VCBO® ADDENDUM 001

project	PCSD Trailside Elementary Addition	project no	21635.04
date	2024-03-27	no. pages	
owner	Park City School District		
contractor	Hughes General Contractors		
bid date	2023-04-04	bid time	2:00 pm

Date: March 15, 2024
Subject: Trailside Elementary School Addendum 1
Project No. #21376

ADDENDUM 01 SHEET REVISIONS

CS210:

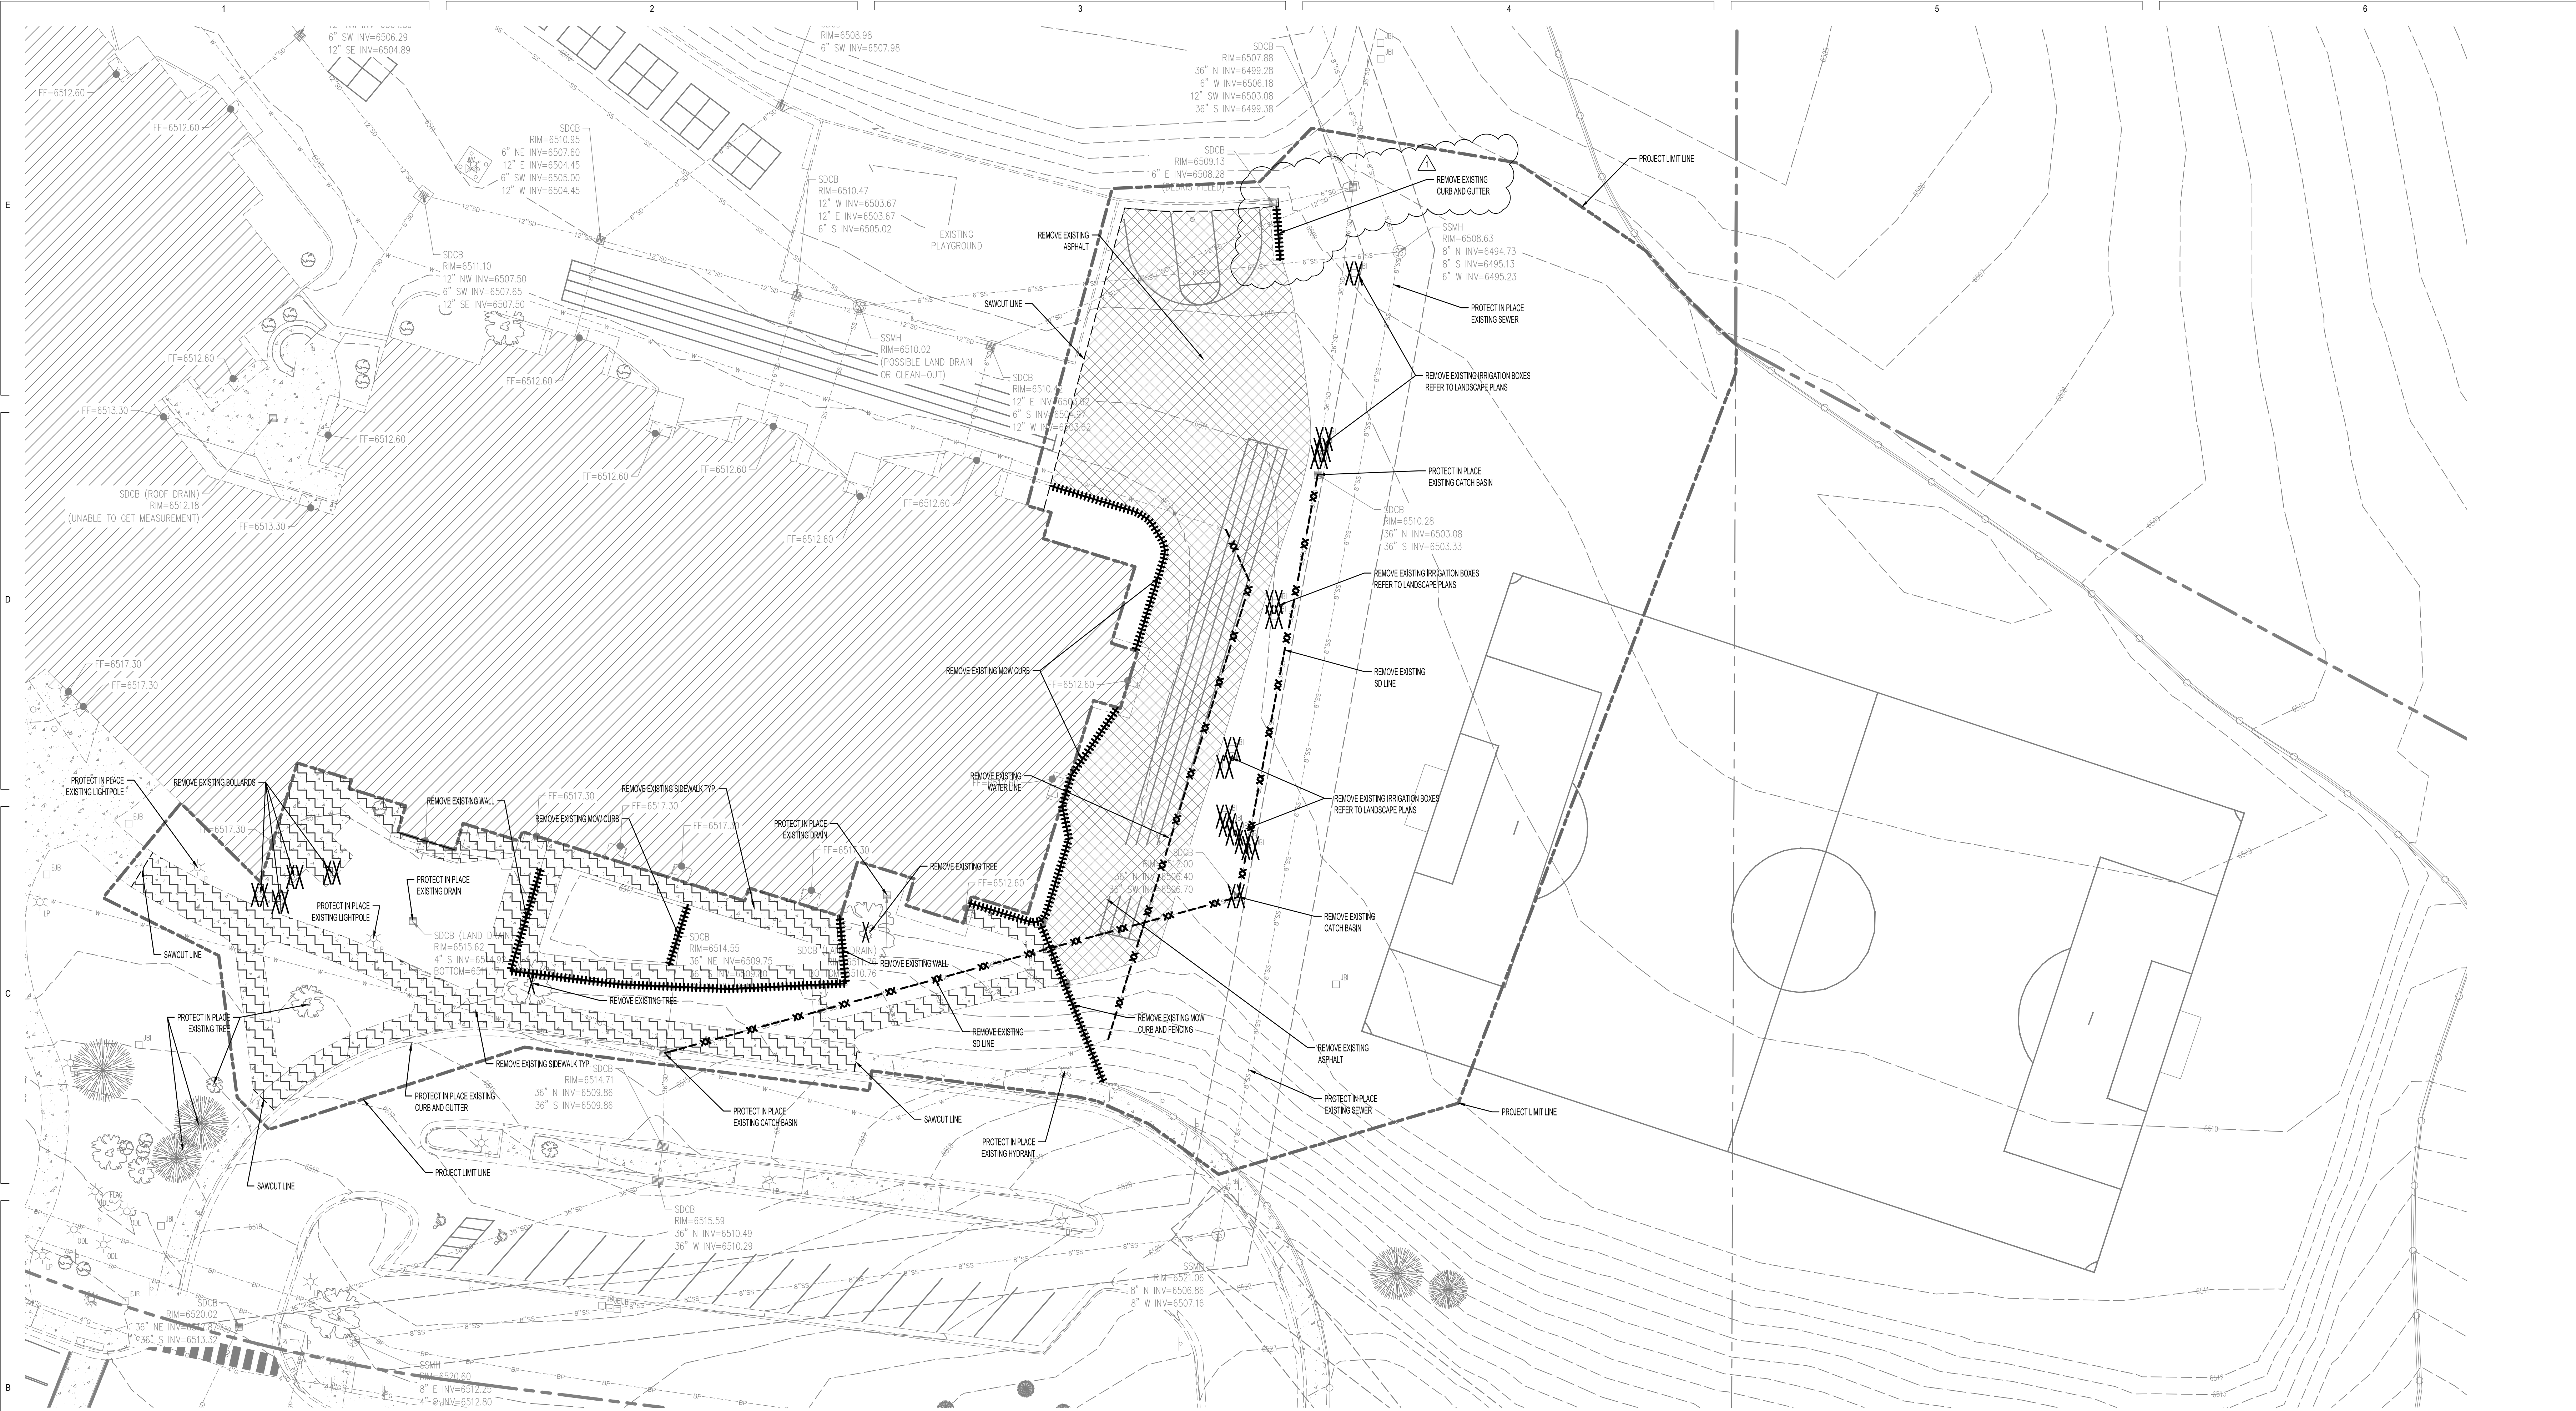
- Additional curb and gutter removal added at the north end of the site.

SITE PLAN

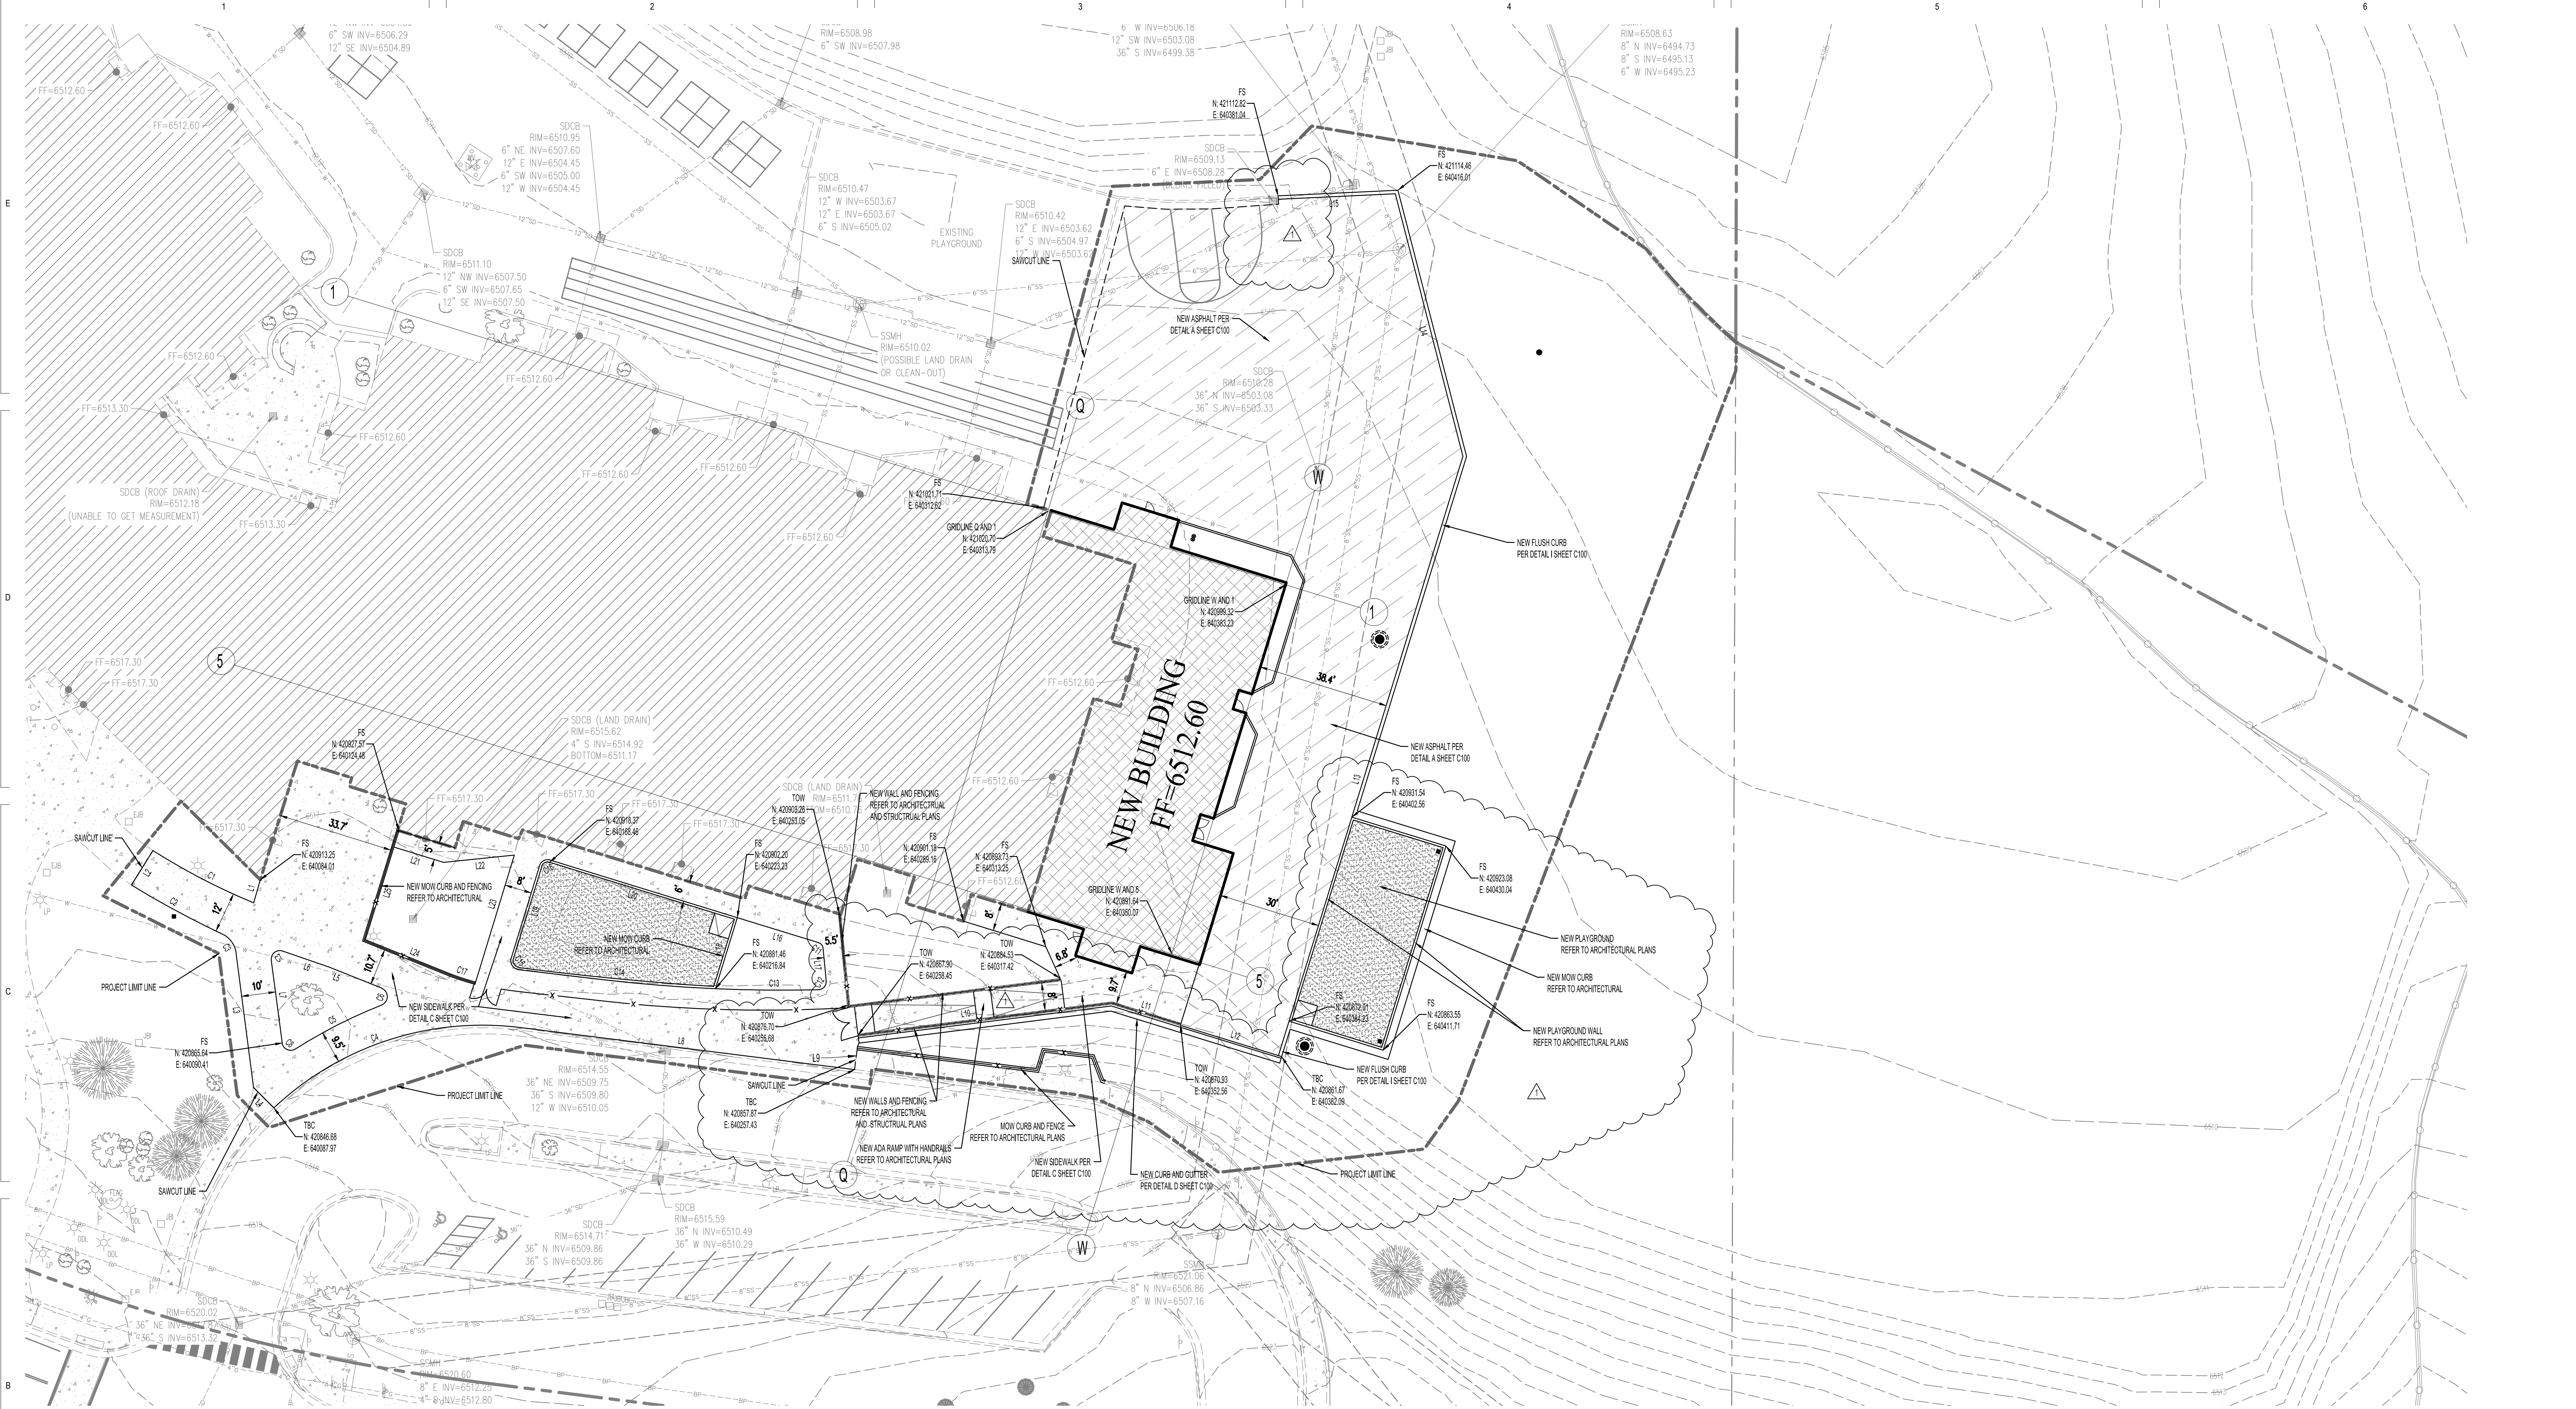
- East playground area has been shifted.
- Wall alignment has been changed.
- Existing curb and gutter removed at the north end of the site.
- Wall thicknesses adjusted.
- Curb and gutter layout adjusted to match with wall revision.
- TBC end south of playground has been shifted.

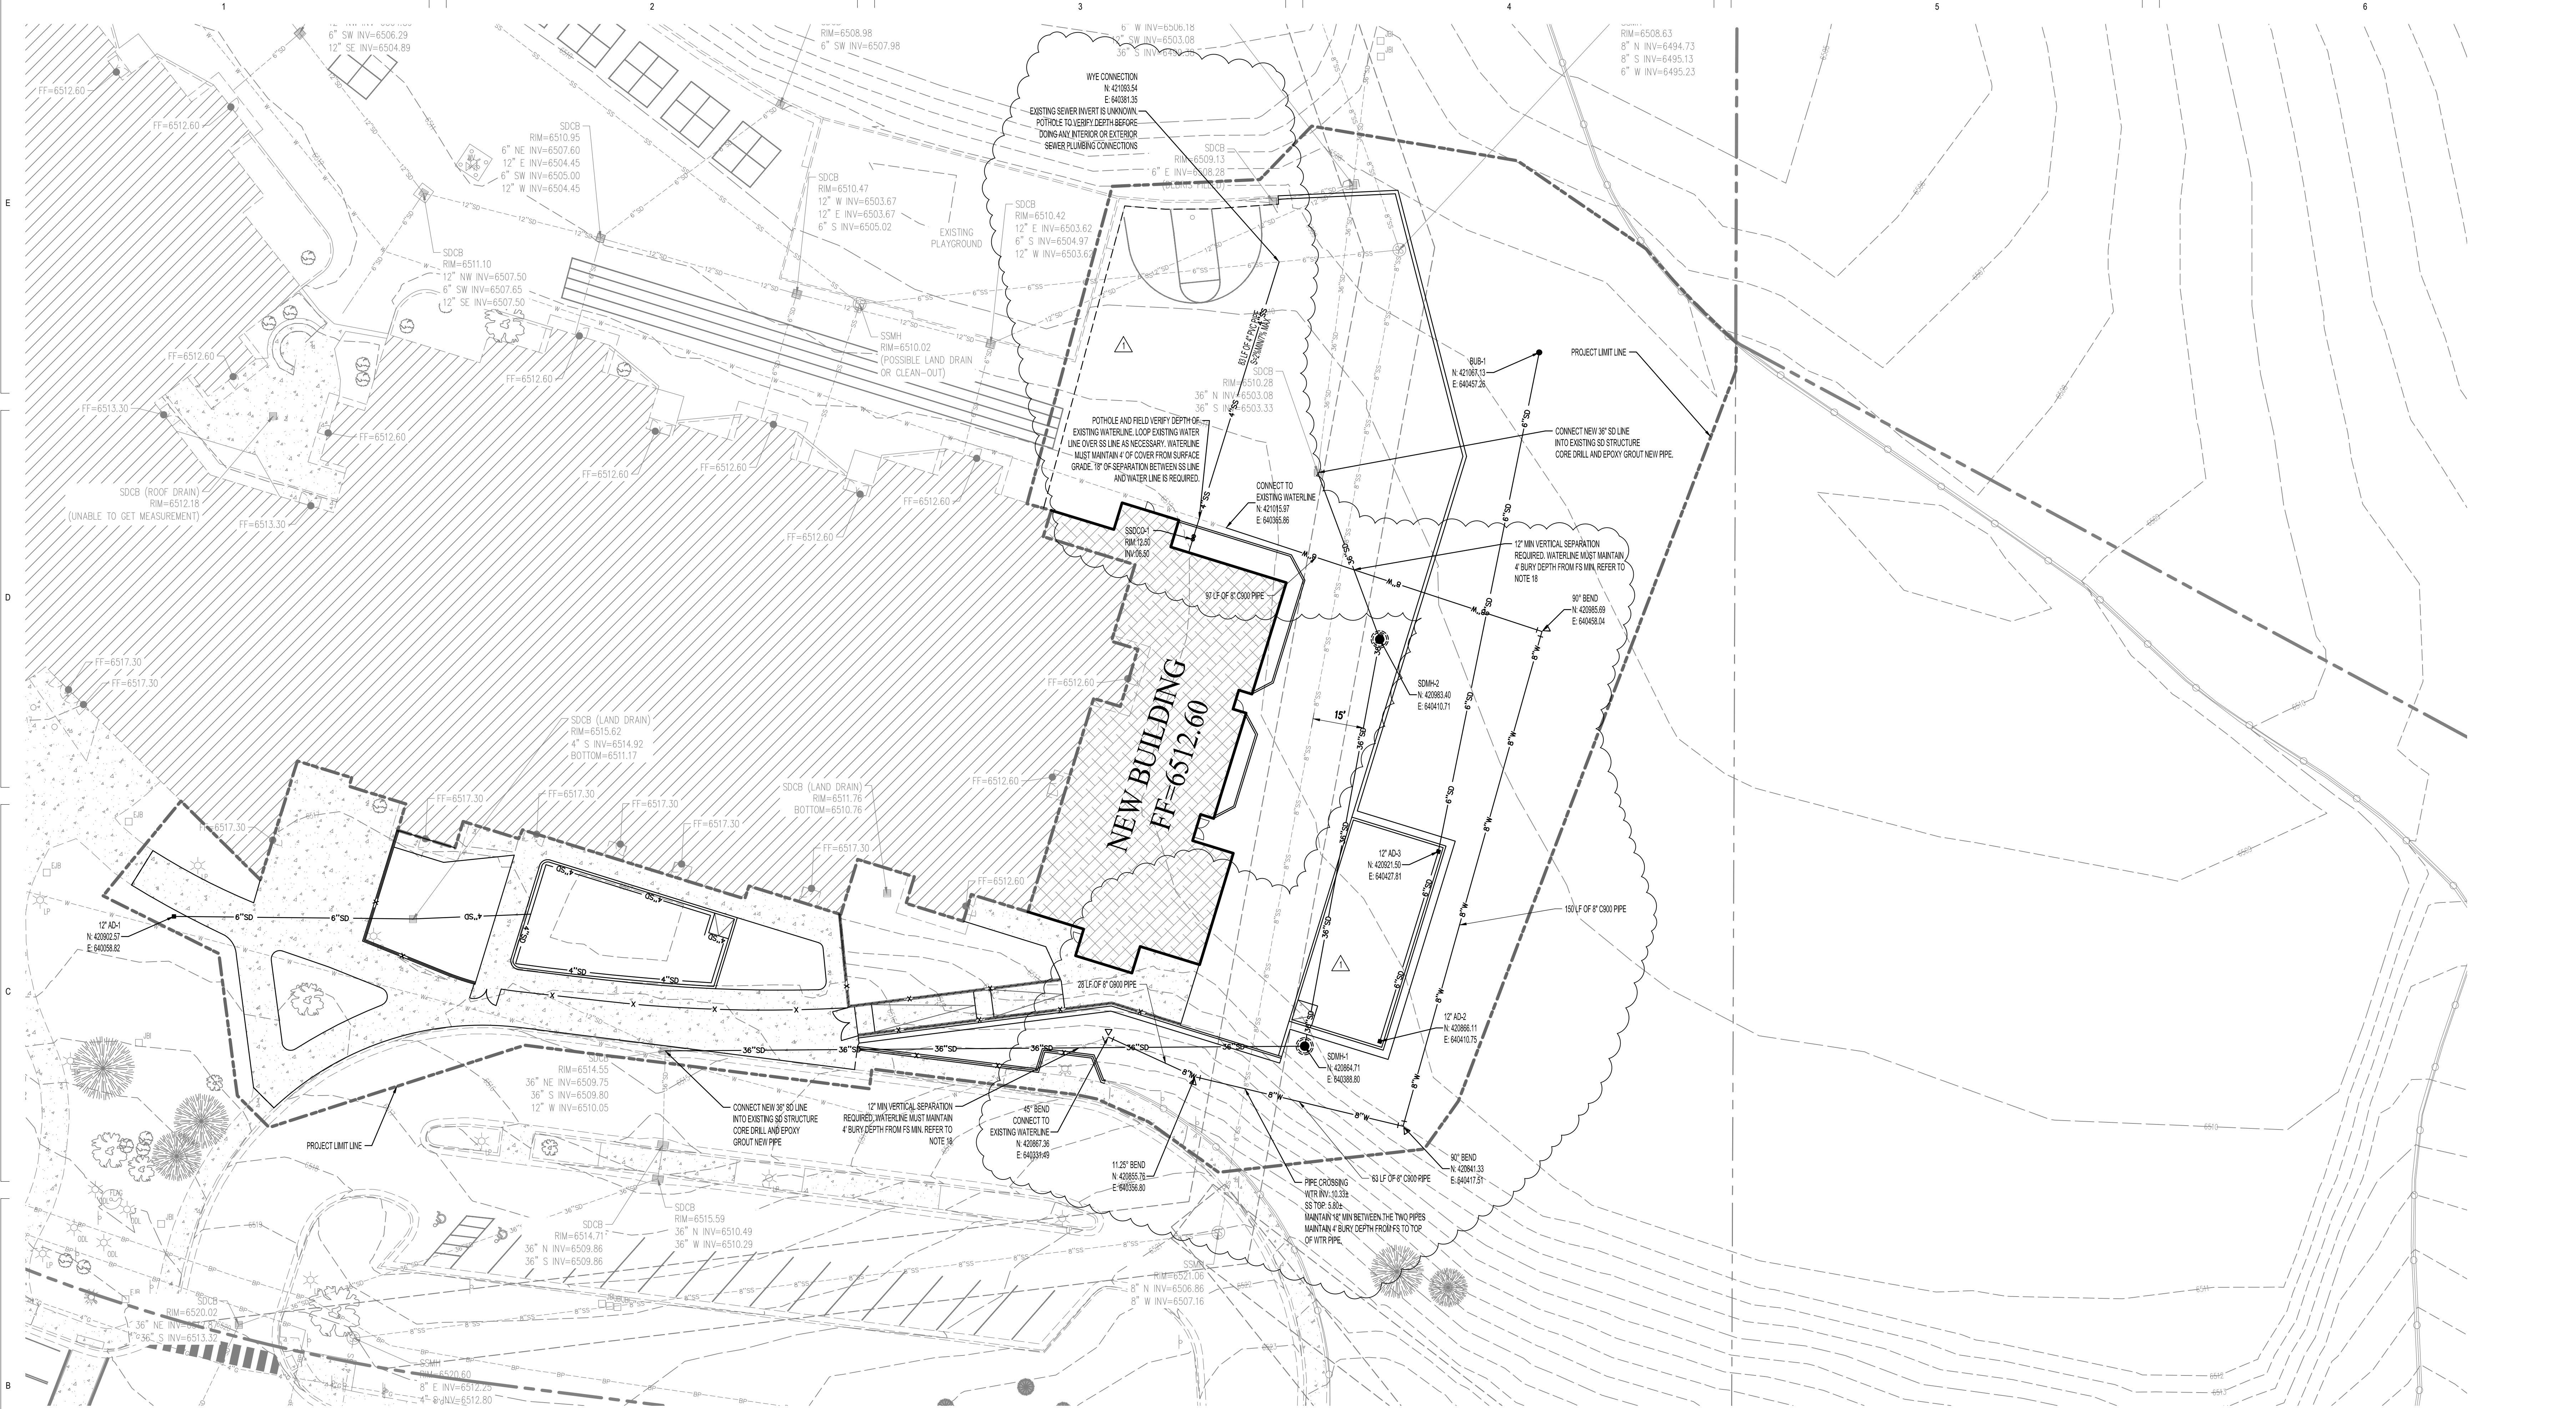
- Sewer line layout adjusted to match plumbing plan.
- Water line layout adjusted.
- 12" AD-2 and 12" AD-3 have been removed.
- 12" AD-4 and 12" AD-5 have been renumbered to 2 and 3 respectively.
